**RANCHO SANTIAGO COMMUNITY COLLEGE DISTRICT**

**ADDENDUM No. 2**

Bid #1388 Welding CMU Wall Extension  
at  
Santa Ana College

**September 15, 2020**

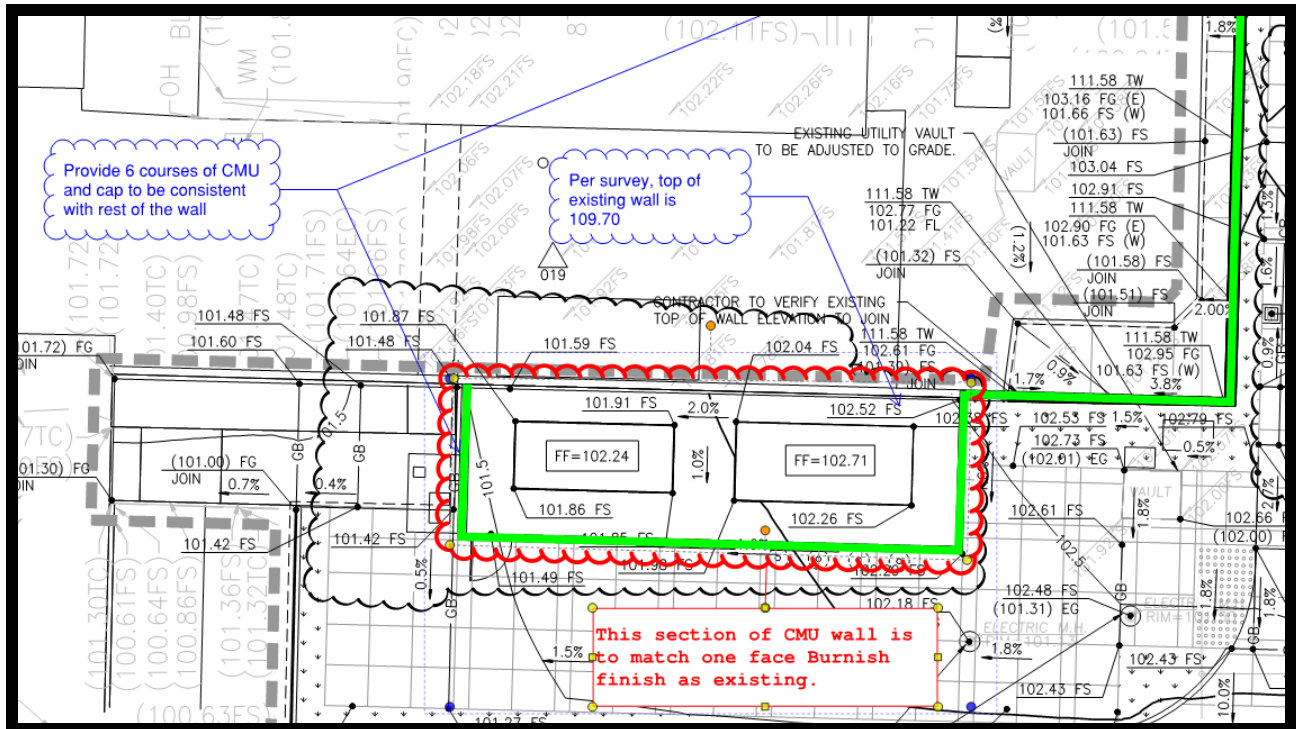
*Question:* Please Provide Detail Plan with the area of (1) face Burnish Finish and (2) face Burnish Finish CMU blocks.

*Answer:* The existing Generator Enclosure wall has only a single side finish. The interior portion of the Generator enclosure is un-burnished. All other locations walls are to be double side burnish. Contractor shall match the existing condition where the new CMU walls are extended. See below drawing.

**Item No. AD 2-10: Scope Clarification**

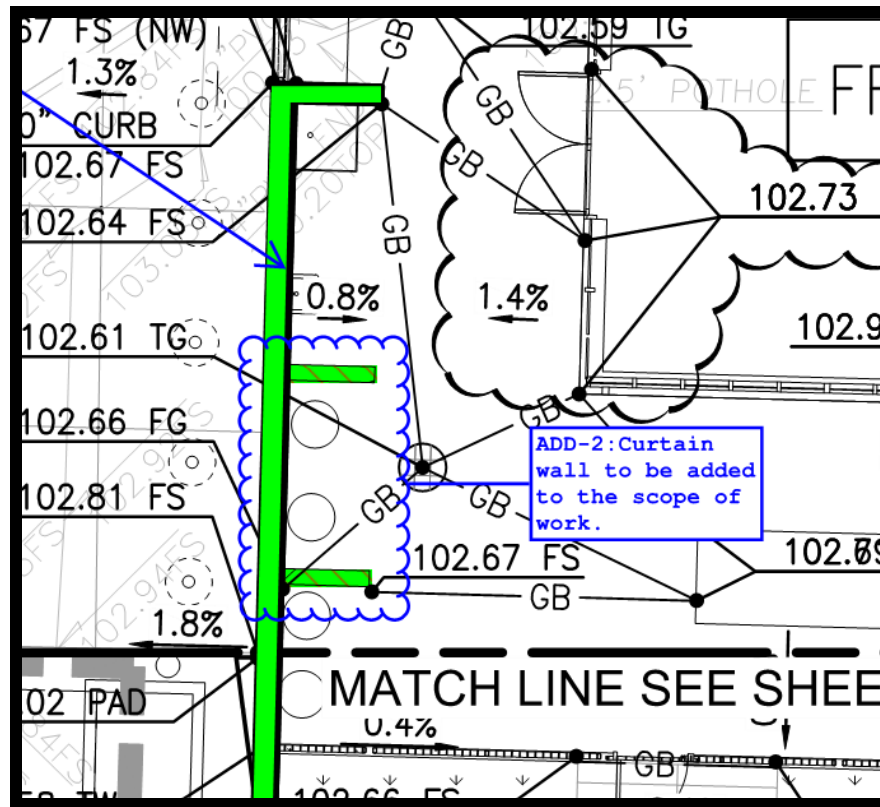
Curtain walls to be included in the scope of work as shown below.
